Re: Barn at Traphouse Nurseries, Allensmore, Hereford HR2 9BP

Application No: S122006/F

Barn at Trap House Nursery, Cobhall Common

Inspection/meeting 21st June 2013

Inspection 21st June 2013

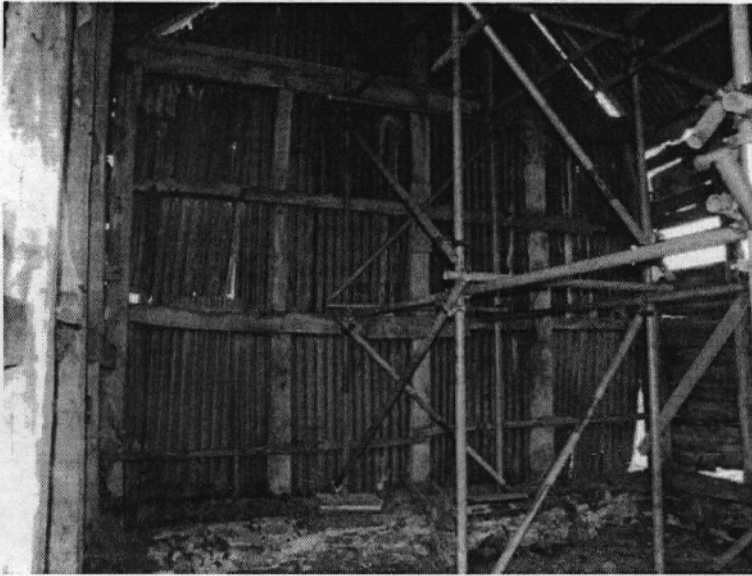
Internal view of the right gable and the internal scaffold.

Note the planted on timbers inside the original timbers.

Front wall - the remains of the 1st floor supporting timbers are to be removed.

Roof and truss. Truss to be retained.
Timber braces to be retained.

New purlins.

Inspection 21st June 2013

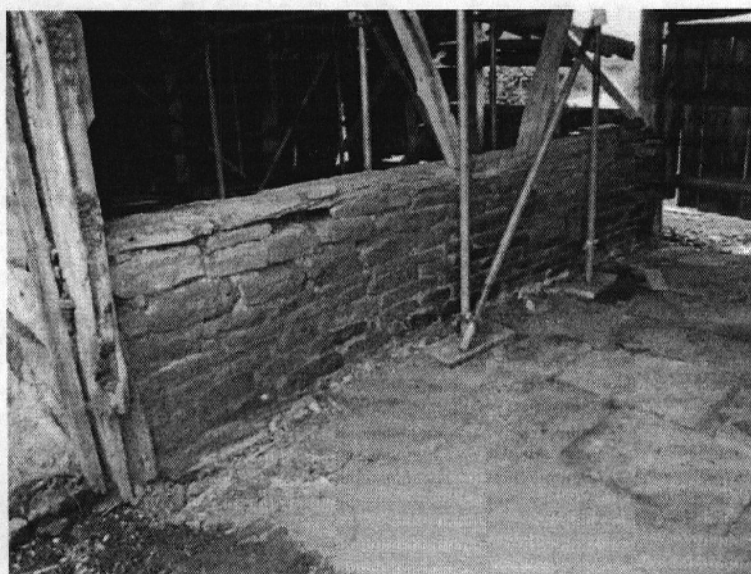
Trial pits on the gable shows that there is little masonry below ground level. Underpinning is required.

The gable wall plinth wall stonework is to be retained.

Note that there is an issue concerning the first 1.5m on the front wall return which is in reasonable condition and has to be retained but the proposal for re-building has the stone face out from the existing.

Issue to be resolved.

Walls either side of the cartway. Both lean into the cartway, one worse than the other. Both are to be retained, if possible - procedure to be agreed.
